**TO:** Jodah B. Bittle, P.E.  
**FROM:** Clarissa Davis, Planner  
**RE:** Inlet Palms Townhomes; Zoning Atlas Amendment, Preliminary Plat & Planned Development Review  
**DATE:** May 18, 2015

**SUBJECT:** Inlet Palms Planned Development & Preliminary Plat  
1502 Seaway Drive  
TRC Project No. 15-43900001

Re: Inlet Palms Townhomes  
Zoning Atlas Amendment. Preliminary Plat & Planned Development Review

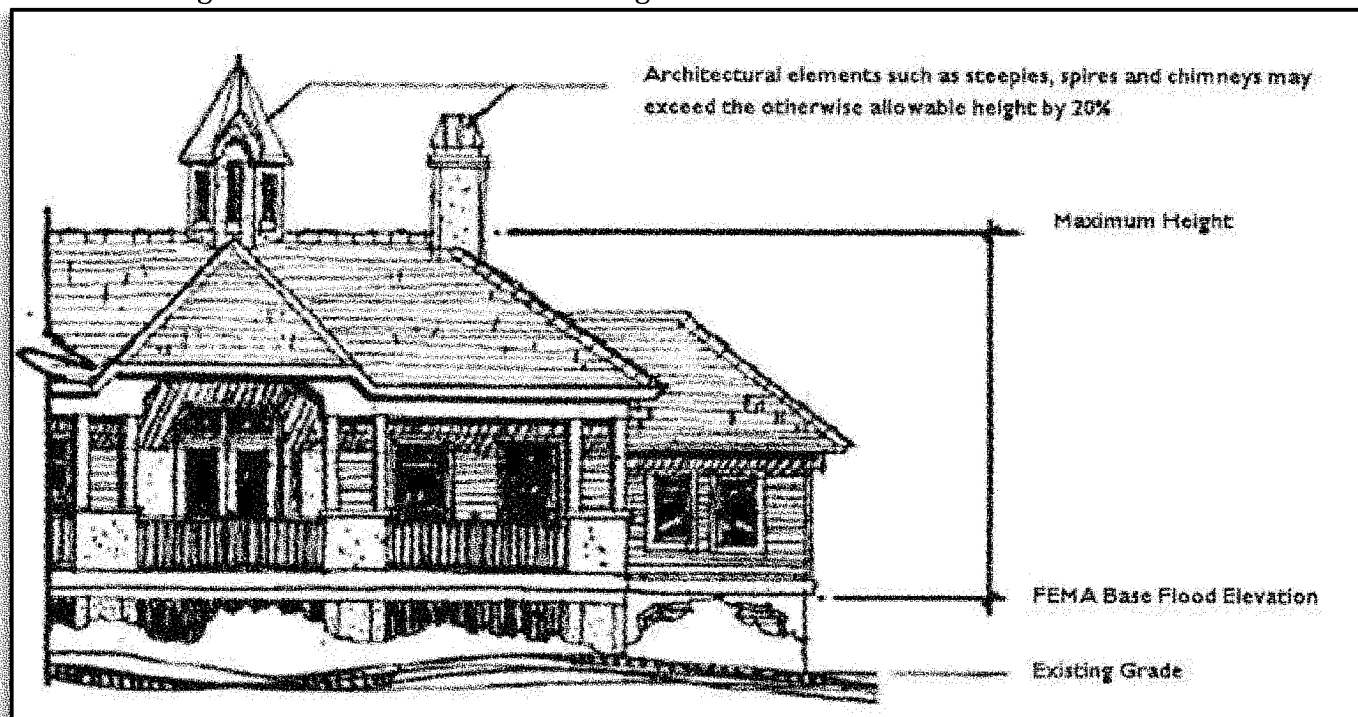
3. Elevation does not clearly describe height and is also inconsistent. Please amend.
4. Height of the structure is determined from Base Flood Elevation to peak of roof. Elevations show Mean Roof Height at 50.67'. Only architectural elements such as chimneys, spires and steeples are able to exceed maximum height by 20%.

**Code Section 22-16(a)(3)(c)1 Calculation of Height:** Maximum structure height shall be calculated from the established FEMA Base Flood Elevation to the highest point of the roof excluding non-habitable architectural design elements of the structure.

1. Attached please find a narrative of the quantitative data for the planned development parameters.
2. The driveway areas for units 1 and 6 have been discussed with City Engineering and have been revised accordingly.
3. The elevation has been revised to clearly describe the height on the cover sheet.
4. The elevation has been revised to clearly describe the height on the cover sheet.
5. As discussed, the sidewalk between units three and four is for all units and not exclusive to unit seven. Therefore, no pedestrian pathway is required from unit seven.
